# San Mateo County Board of Supervisors' Meeting

**File Numbers: PLN 2005-00116**

**Initial Study Pursuant to CEQA**  
**Project Narrative and Answers to Questions for the Negative Declaration**  
**File Number: PLN 2005-00116**  
**Trautman Resource Management Permit, Coastal Development Permit, and Grading**  
**Permit for a New Single-Family Dwelling**

# Site Plan

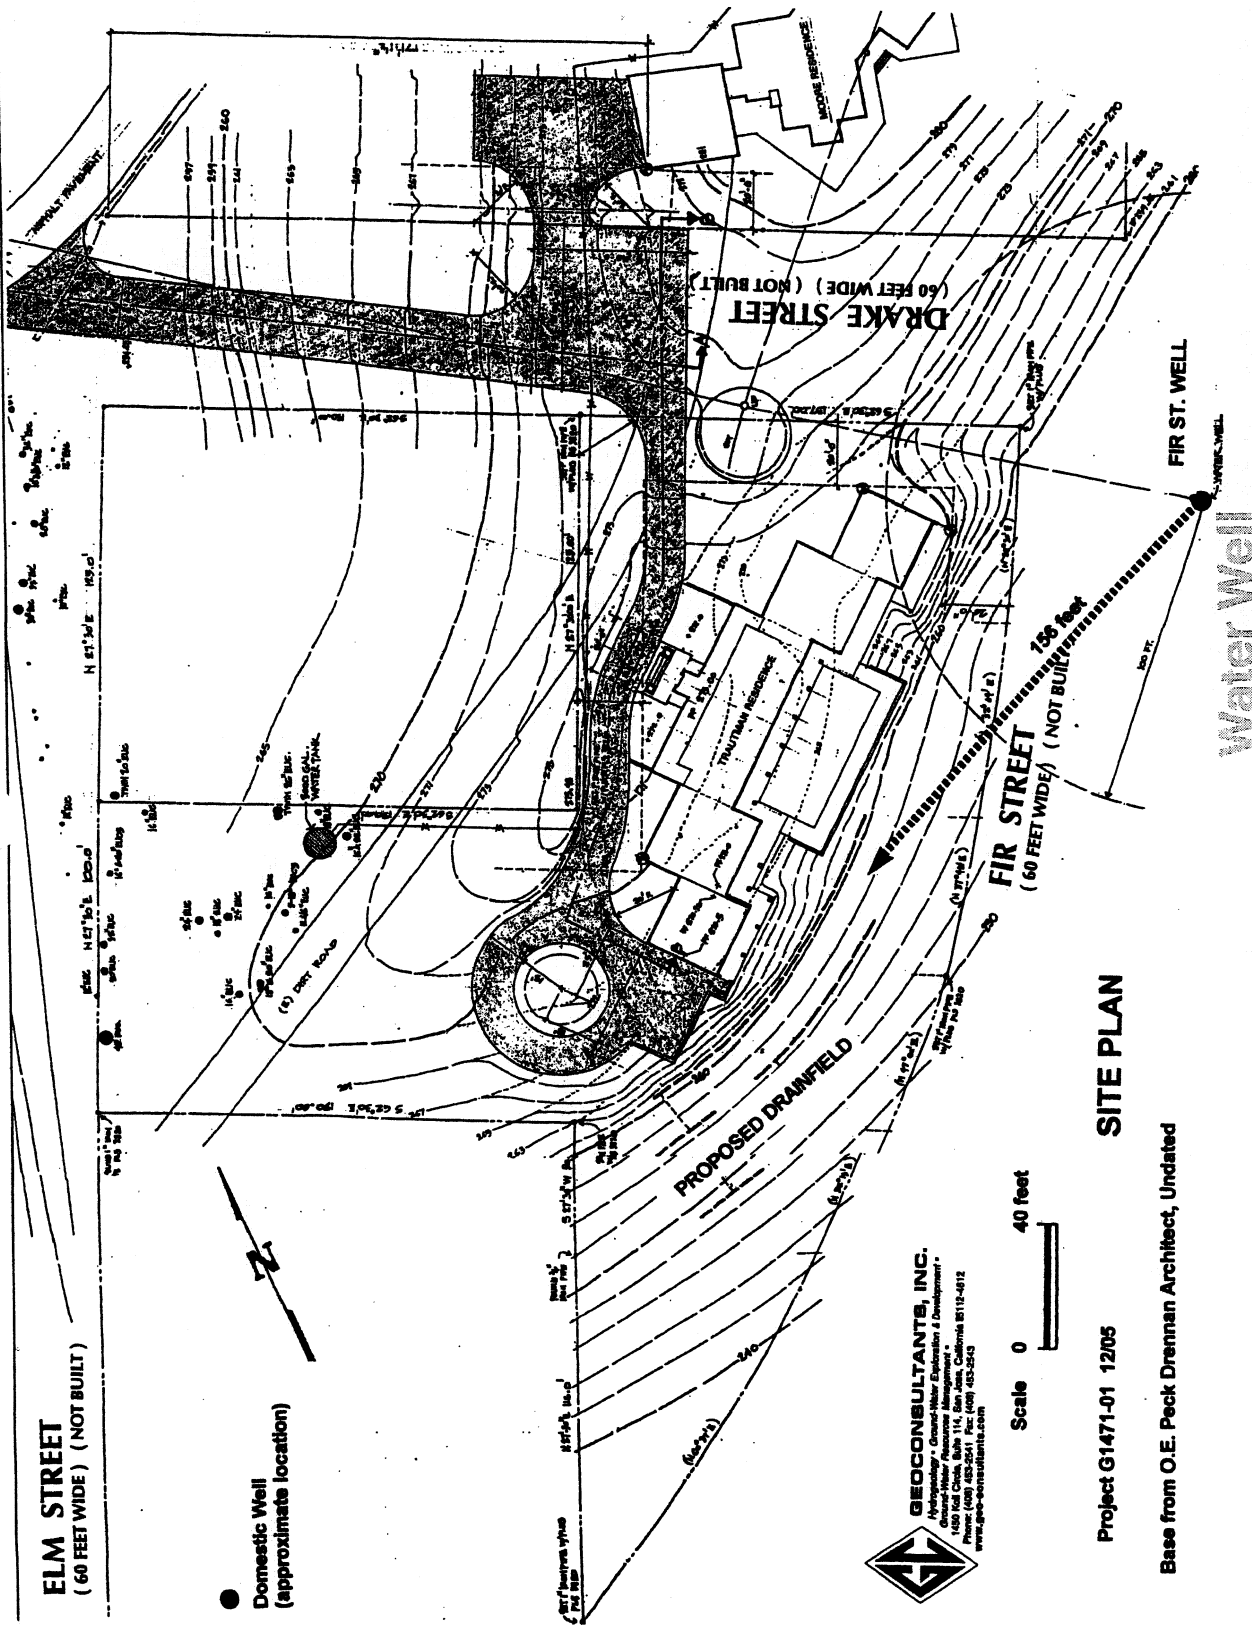
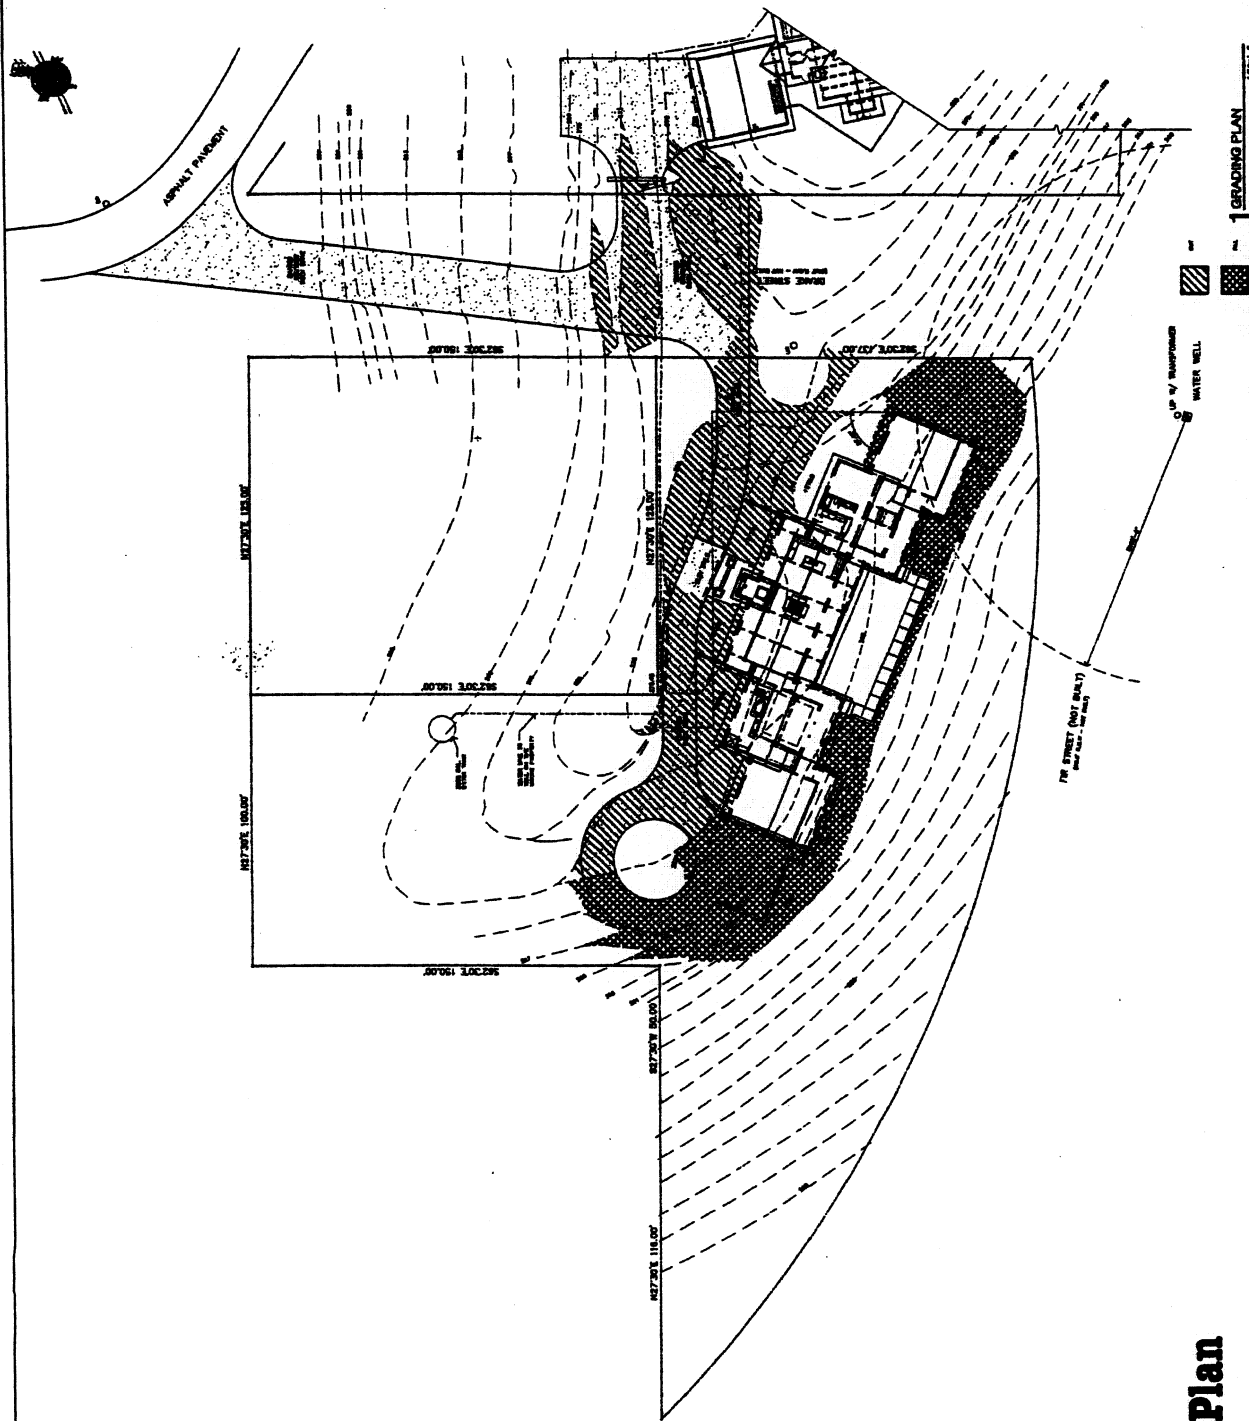
- ❖ The location of these public wells must be marked on the site plan.
- ❖ The septic setbacks from the property line, creek, and MSWD water supply must be clarified and confirmed and must comply with applicable rules.

- ❖ The location of the well and how the water will get to this house must be marked on the site plan.

# **Two Main Hydrologic Points of Appeal...**

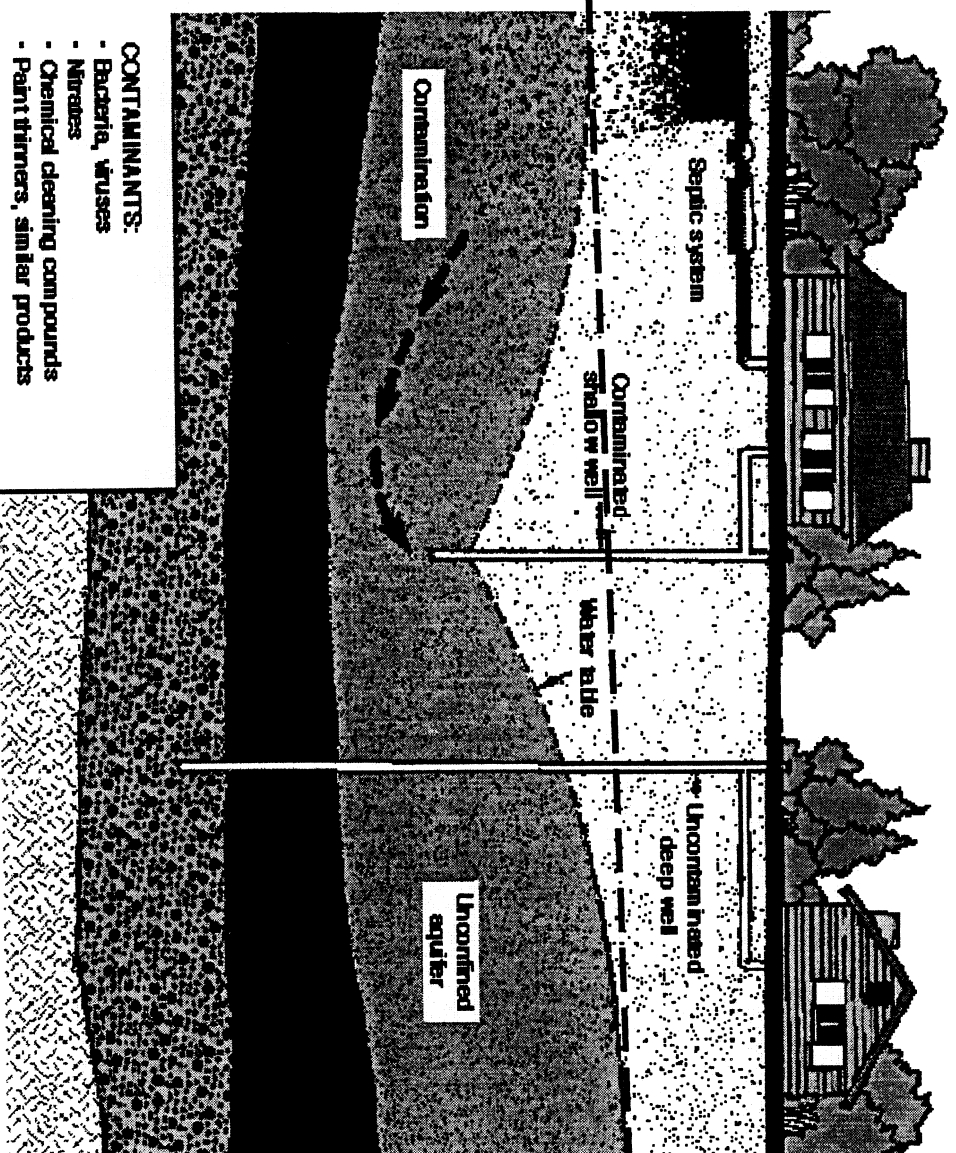
- County Staff has accepted an deficient hydrogeologic report that concludes “no impact” to the District's production well.
- The 100-foot setback from septic fields is not intended for areas around municipal water-supply wells which serve urban populations.

# Characteristics of the Drake Well

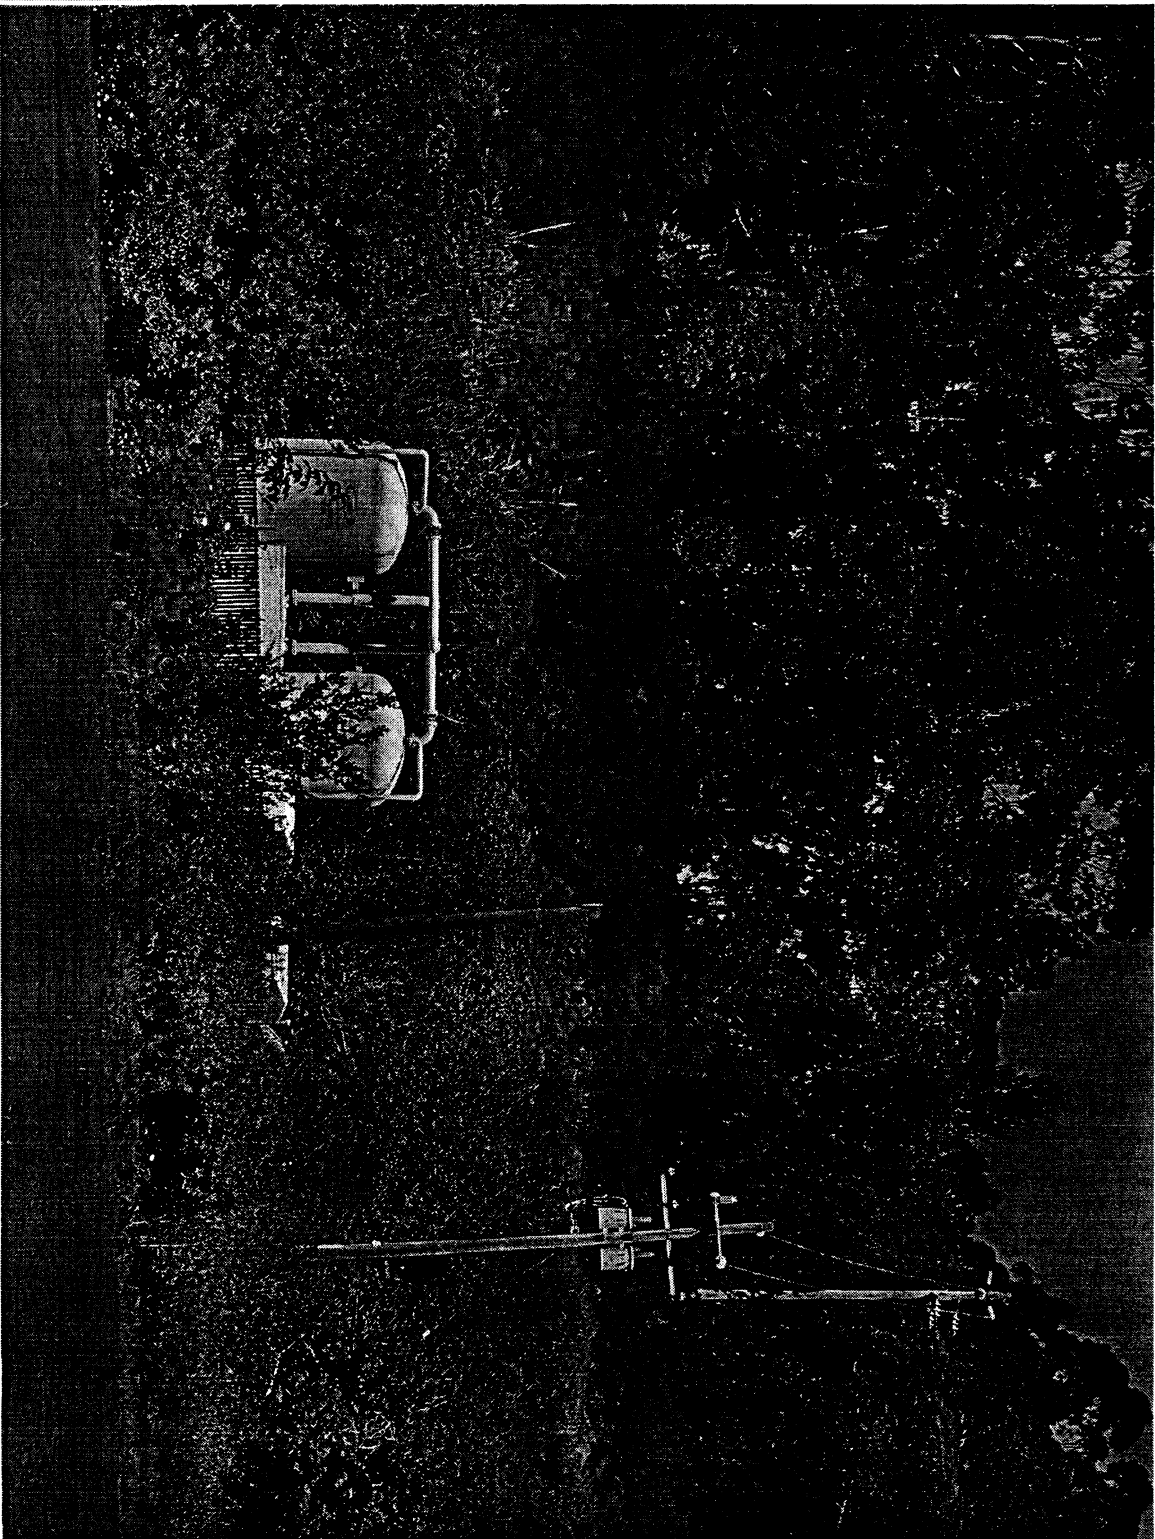
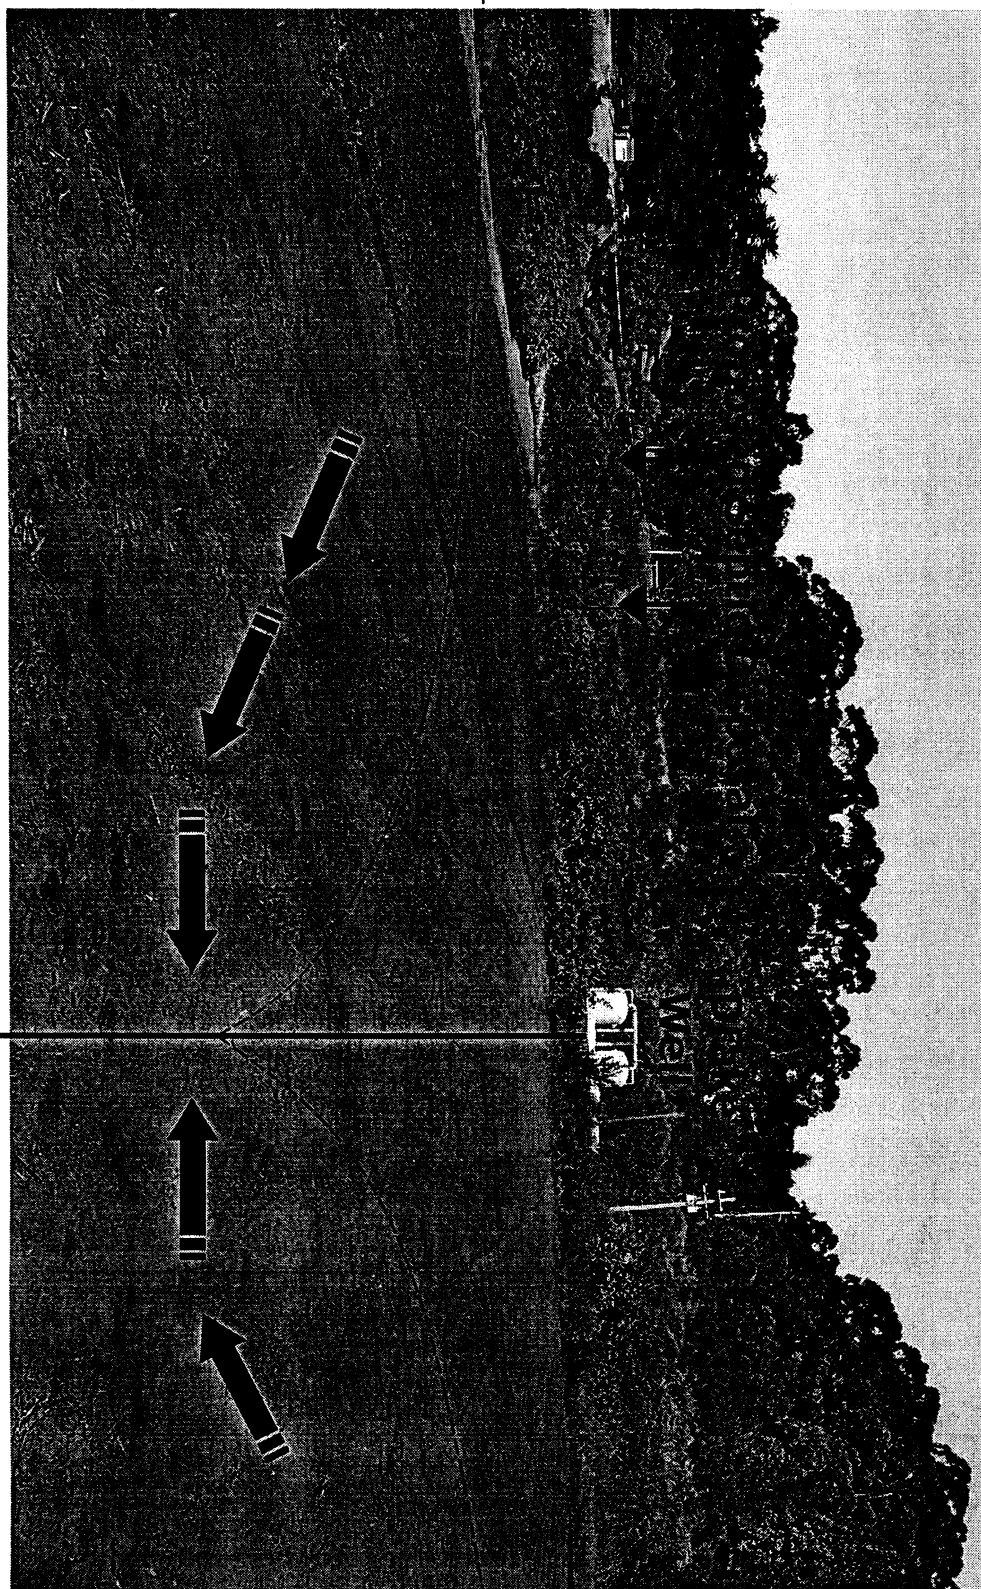
- 188 feet deep and yields 40 gallons per minute.
- More than 40 percent of flow from near-surface ground water, vulnerable to septic leachate contamination.
- Lowest depth to water in 2005 was 86 feet below ground surface, at an elevation of 124 feet.
- MTBE filtration system for protection from upgradient source
- Nitrate detected at low levels
